**DECISION, CONDITIONS, FINDINGS OF FACT, AND CONCLUSIONARY FINDINGS OF THE
MCMINNVILLE HISTORIC LANDMARKS COMMITTEE FOR APPROVAL OF THE ALTERATION OF
A HISTORIC RESOURCE AT 711 NE 3RD STREET**

- DOCKET:** HL 5-18
- REQUEST:** The applicant has submitted a Certificate of Approval application to request the alteration of a historic resource that is located within the Downtown Historic District that is listed on the National Register of Historic Places and is also listed on the McMinnville Historic Resources Inventory.

The proposed design for the reconstructed storefront window systems and entries can be seen below:

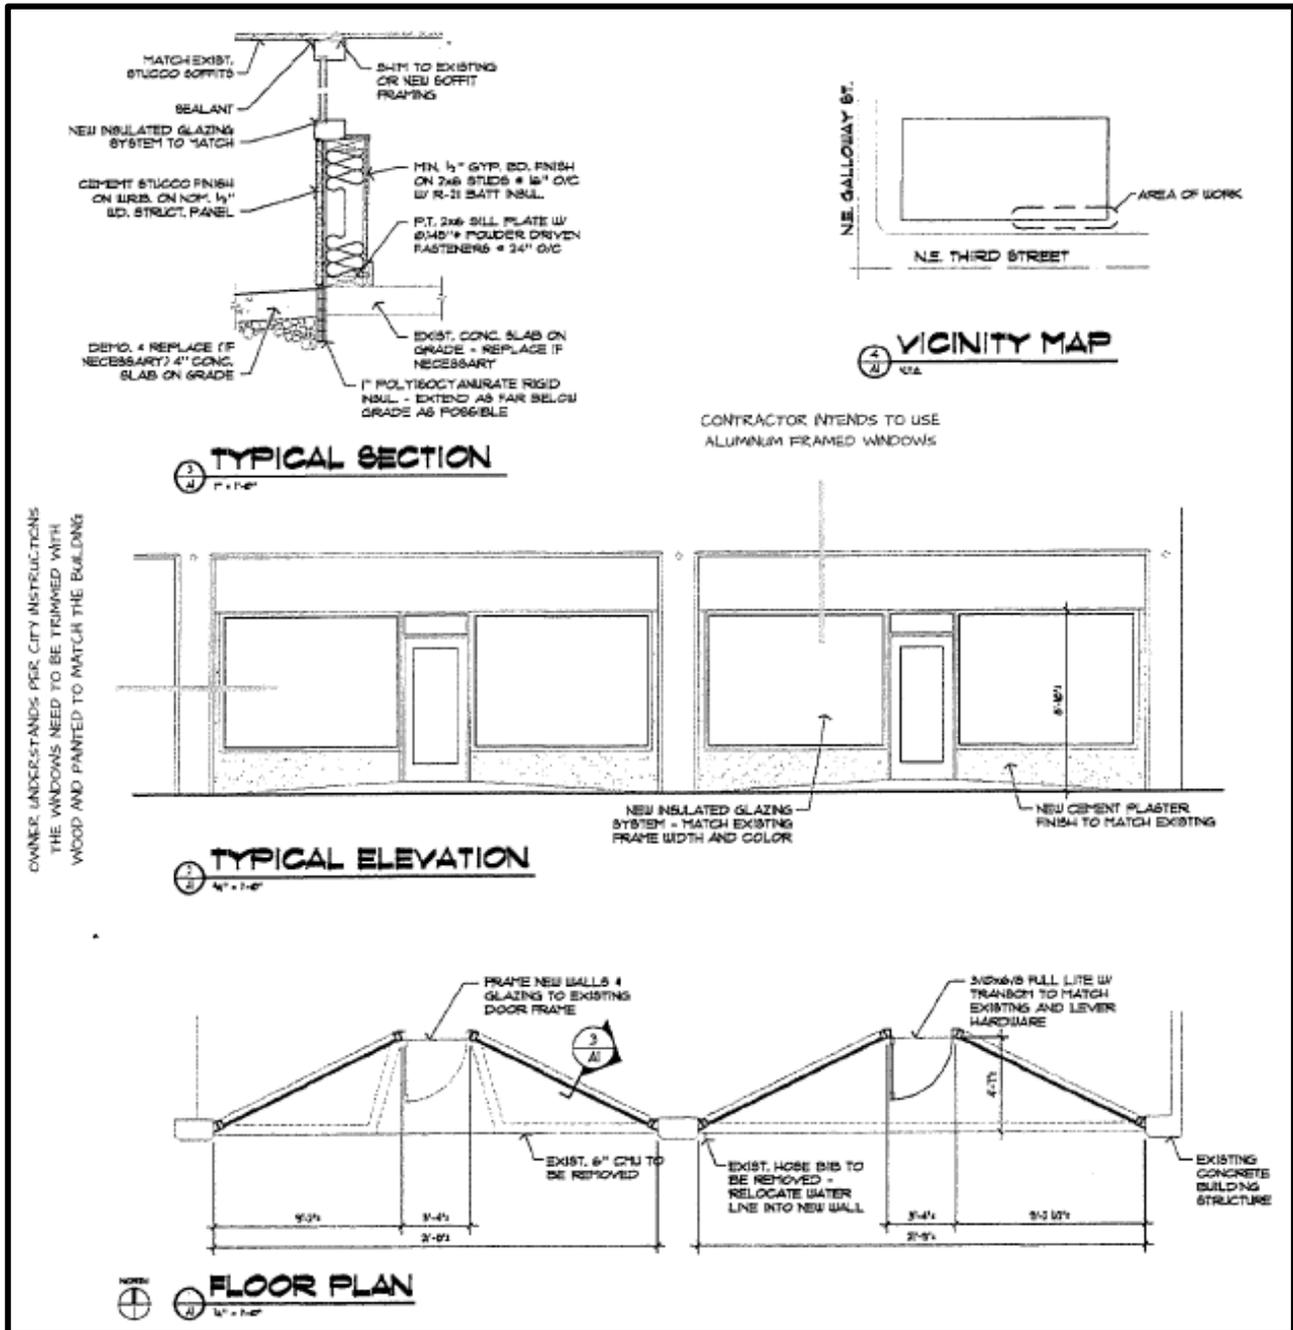
Additionally, the design has inadequate maneuvering clearance for ADA on the latch side of the doors.

The glazing that will go adjacent to the doors will need to be safety glazing as well as the glazing within the doors.

Door hardware must be ADA compliant (e.g., lever-type).

The threshold height is not indicated but must be held to a maximum of ½ inch for ADA.

If the awnings are to remain, it appears they will need to be remounted with the façade change.

In terms of the specific materials proposed, the proposed aluminum storefront windows were not found to be physically and visually compatible with the existing historic materials and features of the building. The applicant is proposing the aluminum windows in order for the bays to be consistent with the other aluminum storefront window systems that exist in the other bays on the ground floor of the building, and has also provided arguments for how aluminum storefront windows may have been in use during certain periods in the past. However, there is no evidence that the existing aluminum windows were historic materials that existed on the building during its initial period of construction, which is what led to the building being classified as a Secondary Significant Contributing resource in the Downtown Historic District. The dates of construction for buildings classified in the historic district as Secondary Significant Contributing resources was 1913-1937. The statement of historical significance and description of the property, as described in the nomination of the Downtown Historic District, states that most, if not all, other windows besides the aluminum framed storefront window systems were wood. These include windows that were described as follows: "second floor windows are one over one double-hung wood sash"; "a series of three fixed six-light wood frame windows... located at mezzanine level on the south façade"; "north of the cut away storefront is a bay containing three wood fixed six-light windows"; and "next bay to the north contains a wood frame plate glass window and door". The bays on the ground floor were already altered by the time of the nomination and survey in 1983, as the historic photo of the building from 1927 shows a different ground floor façade. Given that the remainder of the windows on

1. That the storefront windows be wood framed windows, or that wood trim and sills be applied to the exterior of the internal aluminum framed windows.
2. That the applicant shall submit building permit applications prior to completing any work, and that the construction plans submitted with the building permit applications shall be consistent with the exhibits, drawings, and renderings submitted for review by the Historic Landmarks Committee, and consistent with all applicable conditions of approval.

the building were wood, it has been determined that the storefront windows should be of wood materials to be physically and visually compatible with the historic materials and features of the building. A condition of approval is included to require that the storefront windows be wood framed windows, or that wood trim and sills be applied to the exterior of the internal aluminum framed windows.
